BC FED #1 DEEPENING PROGRAM

CONDITIONS OF APPROVAL

**COG Operating LLC
NMLC029509A
BC Federal #1
30-025-34733
Section 20, T. 17 S., R 32 E., NMPM
Lea County, New Mexico**

Centralizer Diagram

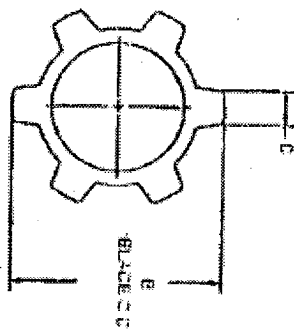
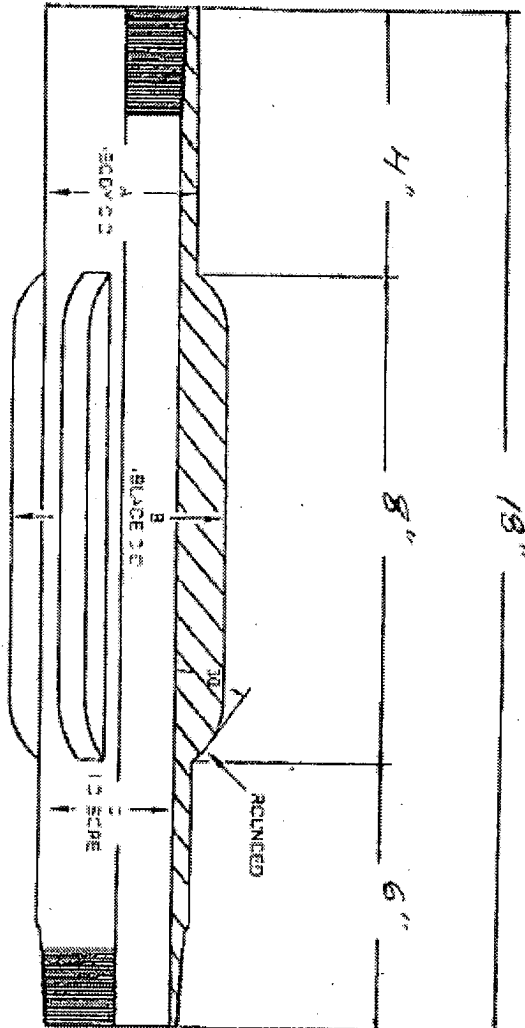
NOTE: COG OPERATING LLC REQUESTS A VARIANCE TO THE 0.422" STAND OFF RULE BETWEEN CASING AND WELLBORE.

Fixed blade stabilizer subs will be utilized in the casing string to insure adequate isolation and seal throughout the wellbore. These stabilizer subs are positive fixed blade type. These subs will actually be screwed into the casing string. A diagram of the fixed blade stabilizer sub is located at the end of this program.

- 5. BOP to be tested to 1000 psi based on expected BHP**
- 6. Variance for stand-off of less than 0.422" is approved due to NMOCD classifying the formations in this area as the Yeso group - Pool 44500 (R-12899).**
